Wisconsin Department of Transportation

Proposal #32: 7550-01-70, WISC 2017 119
Melrose - Black River Falls
STH 71 to 11th Street
STH 54
Jackson County

This is Addendum No. 01, which provides for the following:

ADDENDUM NO. 01
7550-01-70, 7550-01-72, 7550-03-73
March 8, 2017

Addendum No. 01
 ID 7550-01-70
 Revised Sheet 129
 March 8, 2017

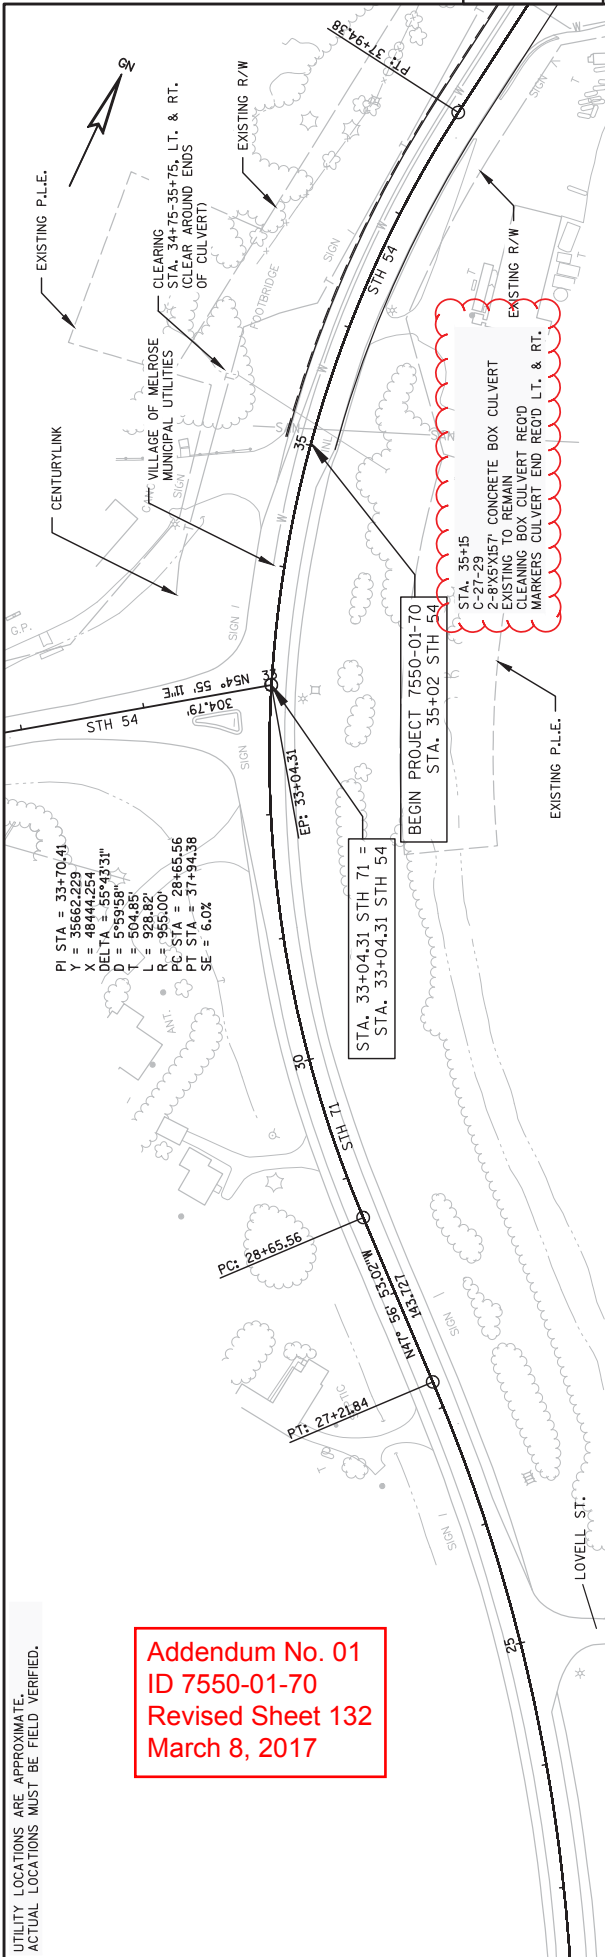
Revised Plan Sheets	
Plan Sheet	Plan Sheet Title (brief description of changes to sheet)
99	Miscellaneous Quantities – Revised Item 520.8700, Cleaning Culvert Pipes
129	Miscellaneous Quantities – Added Item SPV.0060.03, Cleaning Box Culvert, C-27-29
132	Revised Plan Sheet details with the added Item SPV.0060.03, Cleaning Box Culvert, C-27-29

SPECIAL (03. CLEANING BOX CULVERT, C-27-29)

CATEGORY	STATION	LOCATION	SPV. 0060.03 EACH	REMARKS
0010	35+15	LT. & RT.	1	TWIN 8'W X 5'H CONC. BOX
TOTAL 0010			1
